MEMORANDUM

FOUNDATION INVESTIGATION REPORT BY:  
Gecco Limited, Consulting Engineers.  
W.P. 27-63, Hwy. 62, York River Bridge,  
District No. 10, Bancroft, Ontario.

FOUNDATION INVESTIGATION REPORT BY:  
Geocon Limited, Consulting Engineers.  
W.P. 27-63, Hwy. 62, York River Bridge,  
District No. 10, Bancroft, Ontario.

GEOCON LTD  
DRAWING No. T 7590-1

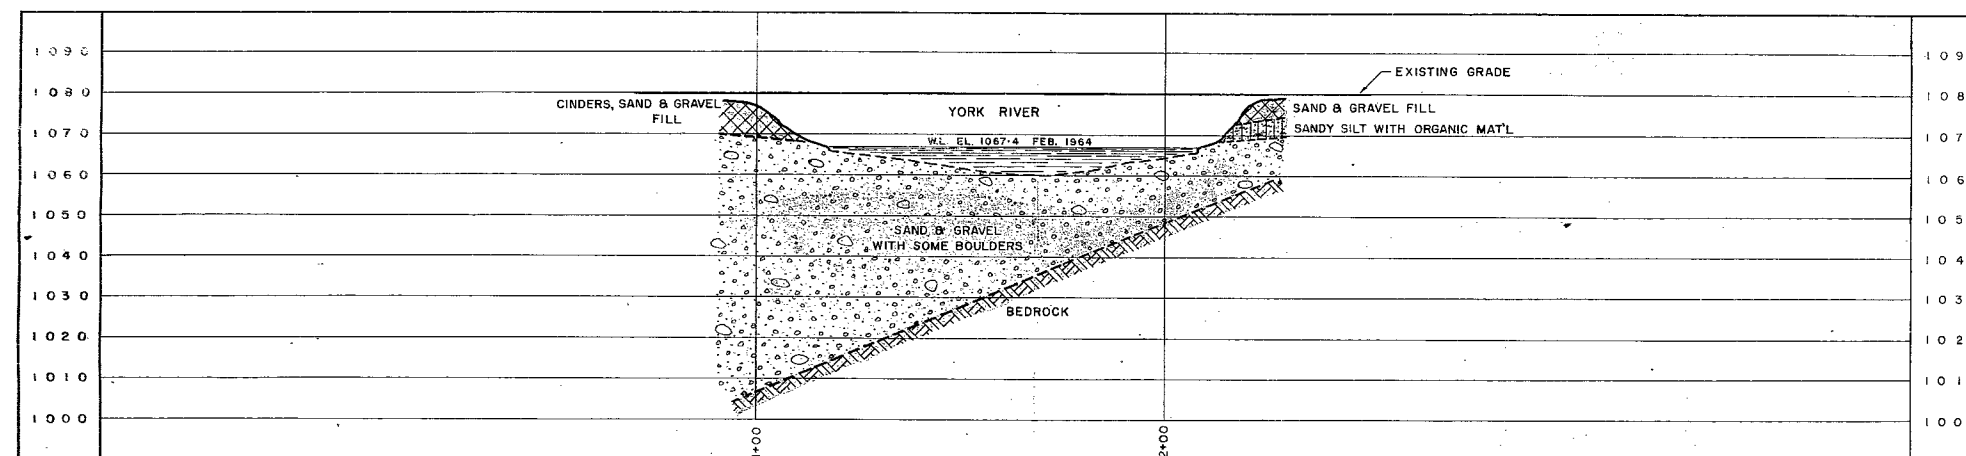
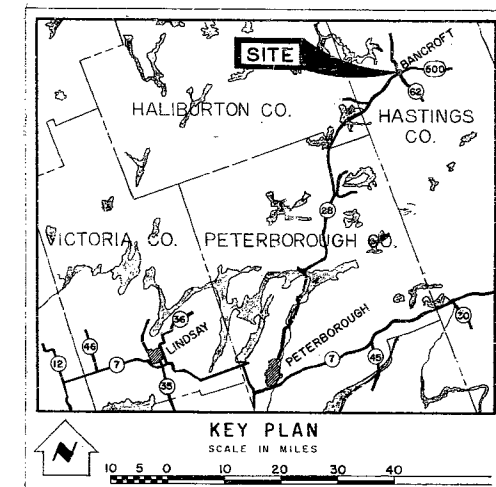
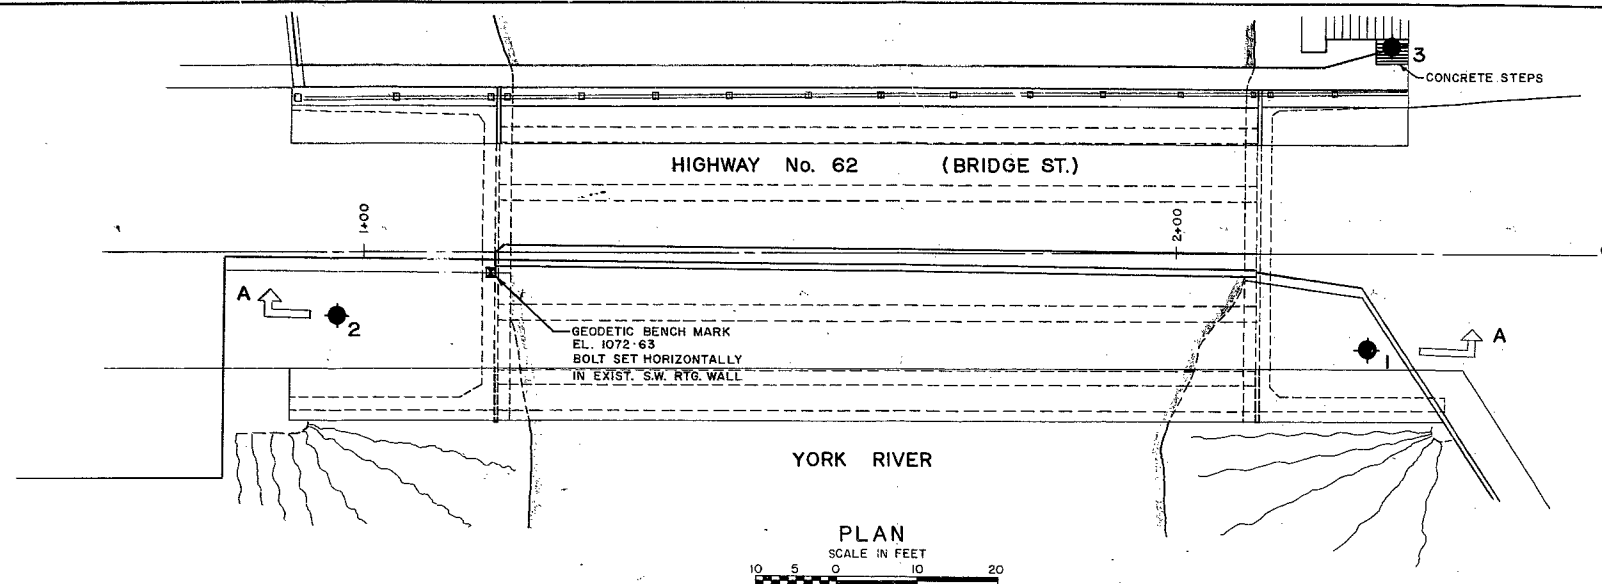
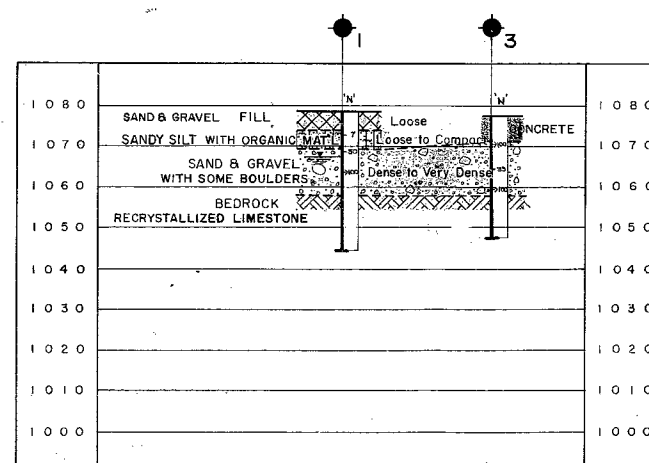
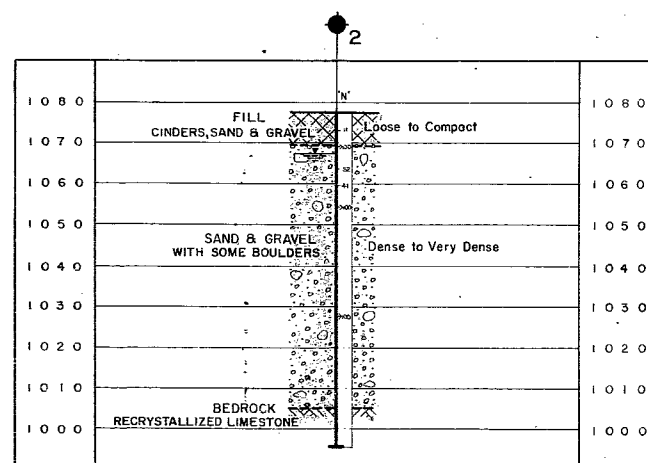
Included in this addendum with the log of borehole 3 are the revised logs of boreholes 1 and 2 together with a revised Drawing T7590-1-1 showing the locations of the boreholes and the inferred soil stratigraphy. A cronaflex copy of the

revised Drawing T7590-1-<sup>A</sup>~~1~~ has been supplied with this addendum. The description of the bedrock as given in our report, dated March 5th, 1964, has been changed on the attached borehole logs and Drawing. The bedrock is identified as recrystallized limestone. The bearing pressure for bedrock, as given in our report, would however remain the same at 20 tons per square foot.
